8. Well Name and No.  
SPUD MUFFIN 31-30 FED COM 331H9. API Well No.  
30-015-45459-00-X110. Field and Pool or Exploratory Area  
CEDAR CANYON-BONE SPRING11. County or Parish, State  
EDDY COUNTY, NM**SUBMIT IN TRIPLICATE - Other instructions on page 2**

Devon Energy Production Co., LP respectfully requests approval for a Name, Bottom Hole, and formation change of the subject well:

## Revisions to Operator-Submitted EC Data for Sundry Notice #445652

## DRILLING CONDITIONS OF APPROVAL

**WELL LOCATION AND ACREAGE DEDICATION PLAT**

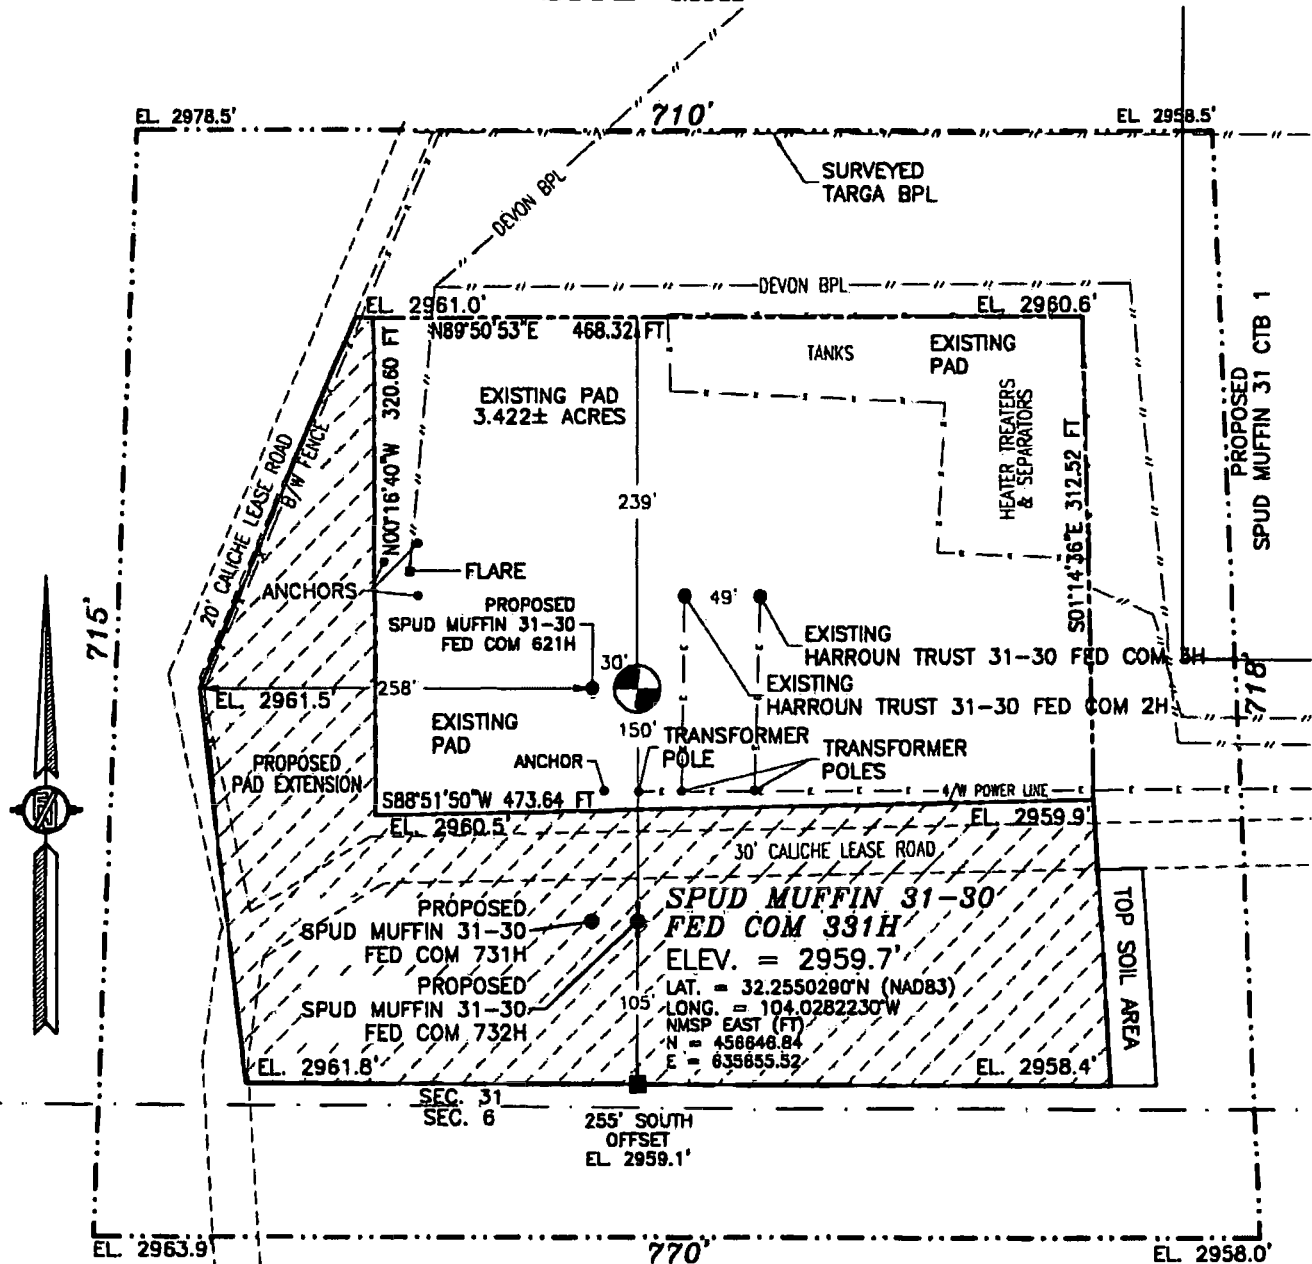
FROM: Sec. 30, T23S, R29E 230 FNL\990 FWL ✓  
To: Sec. 30, T23S, R29E 20 FNL\927 FWLC102?  
PIAT.

UL or lot no.	Section	Township	Range	Lot Idn	Feet from the	North/South line	Feet from the	East/West line	County
1	30	23 S	29 E		20	NORTH	927	WEST	EDDY
